Subject: Submission on the Draft Melton East Precinct Structure Plan (PSP)

**Subject:** Proposed Planning Scheme Amendment C244melt | Functional Design Review for Wetland “WRL 5”

**Subject Land :** 1292 Beattys Road, Grangefields

DRAWN:	J.PETTIFER	AUTHORITY:	----
DESIGNED:	L.PAPAZOIS	PROJECT:	<b>MELTON EAST PSP</b>
CHECKED:	J.MATHIOS		<b>1292 BEATTYS ROAD - GRANGEFIELDS</b>
AUTHORISED:	----	DETAILS:	<b>WETLAND CONCEPT - WLRB5</b>
PE REG NO:	----		
DATE:	----

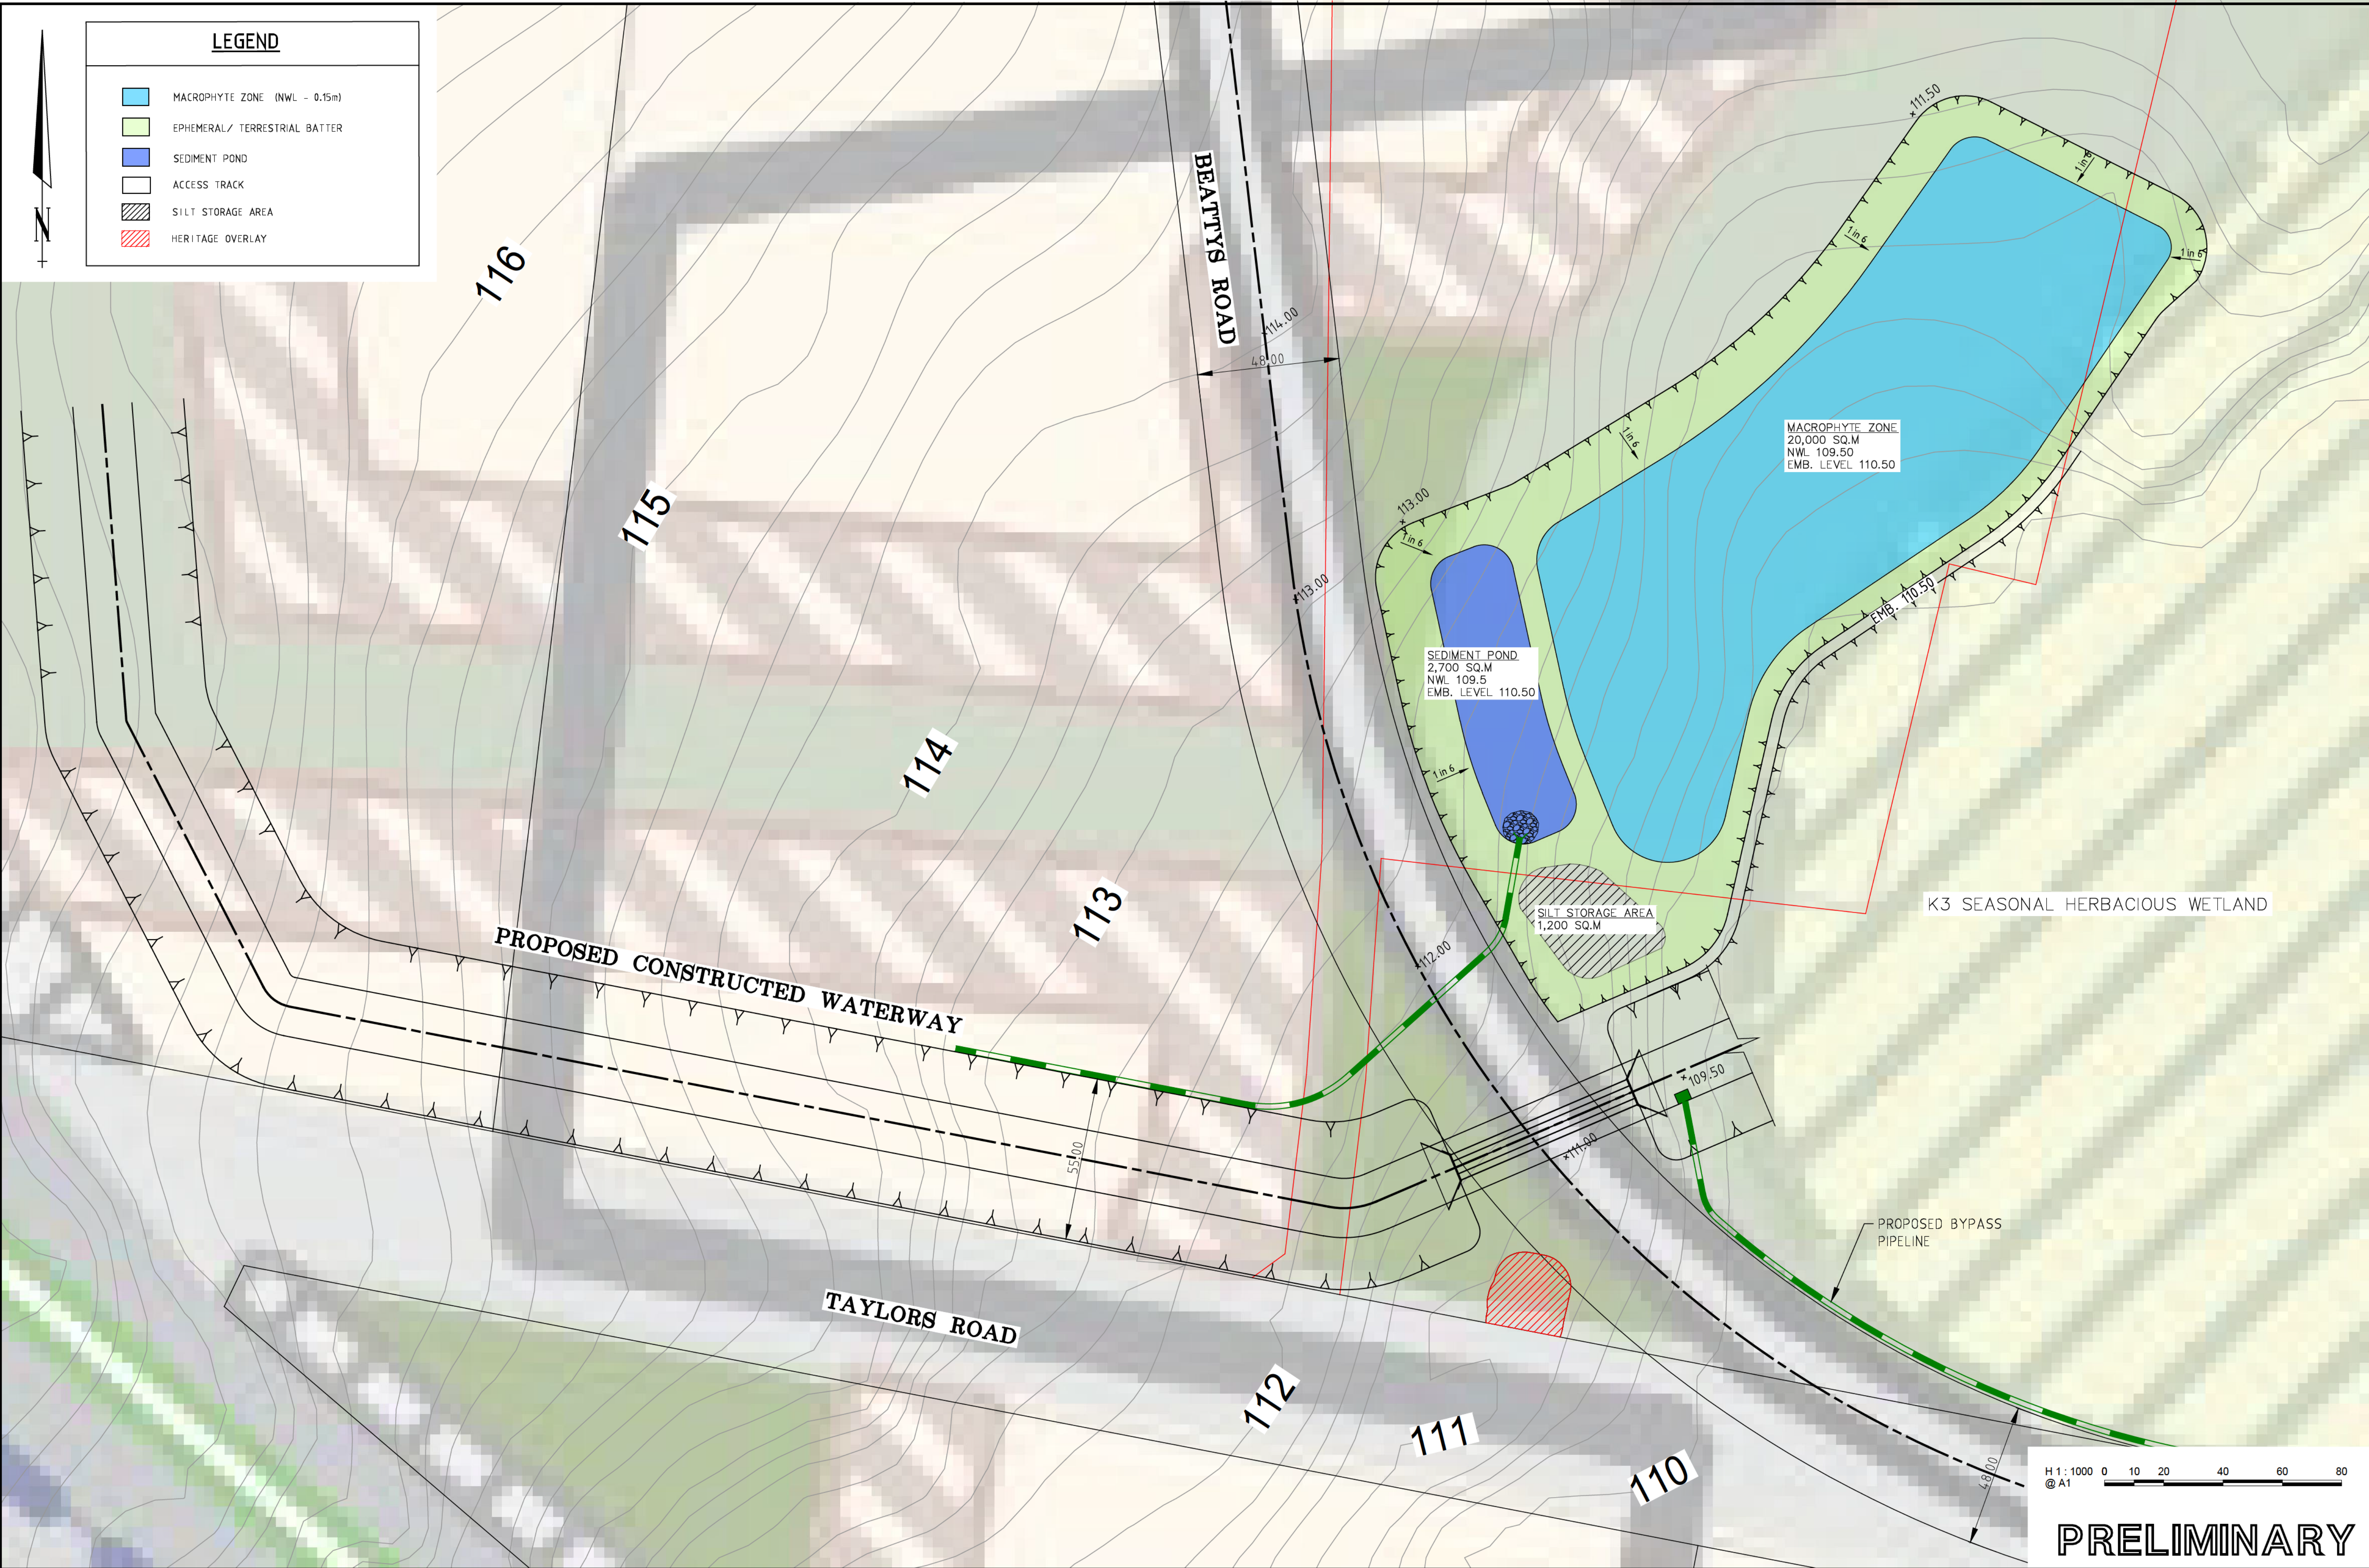
A concept drawing for DPM’s proposal for Wetland “WLRB 5” and Waterway “3B” is enclosed with this letter.

It is submitted that wetland “WLRB 5” is repositioned to the south-east corner of the subject land, absorbing some of the “trapped NDA” between the future Taylors Road realignment and the adjacent “K3” Seasonal Herbaceous Wetland (SHW). This shift follows the direction of the natural valley. The configuration of inlet and outlet pipelines has remained consistent with the Alluvium design.
